Product hierarchy no. *	Part no.	SBU	Type / Description	Customer part no.
SBU   PG   PGU   Type				
01   002   051   00000000558	0031.7601	Circuit Protection	FMS (250V)	-

## 2 Type of change

FMS (250V)					0118.2251	
creation date	created by	release date	released by	notification no.	revision	page
2014-11-27	dislercy	2015-01-29	dislercy		a	1 of 2

Old product appearance	New product appearance

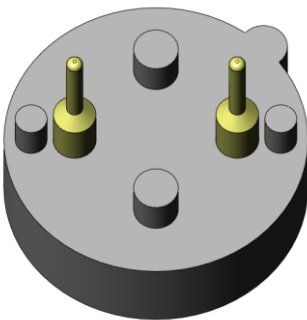
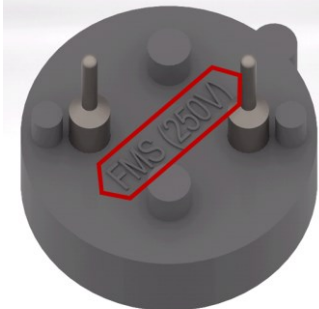
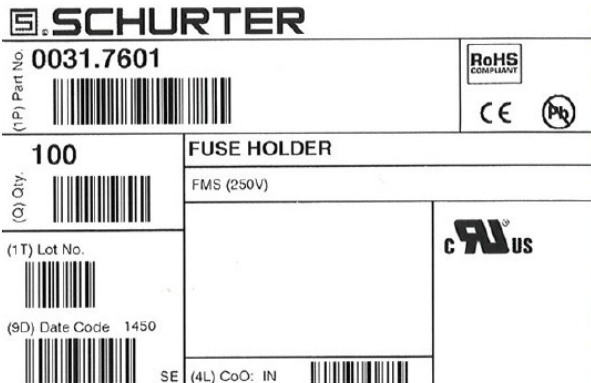
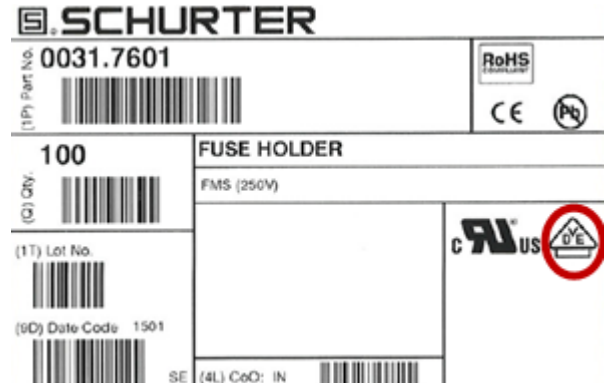
The fuse holder FMS (250V) gets an IEC approval from VDE. Thus, a type inscription on the socket is necessary.

Add a type inscription on the socket as follows:

No rating acc. to IEC available	New rating acc. to IEC

<table><tr> <td>Rated power acceptance</td><td>1.6 W / 6.3 A @Ta 23°C</td></tr><tr> <td>Rated voltage</td><td>250 VAC</td></tr><tr> <td>Rated current</td><td>6.3 A</td></tr><tr> <td>Shocksafte category</td><td>PC1</td></tr><tr> <td>Overvoltage category</td><td>II acc. to IEC 60664-1</td></tr><tr> <td>Pollution degree</td><td>3 acc. to IEC 60664-1</td></tr></table>
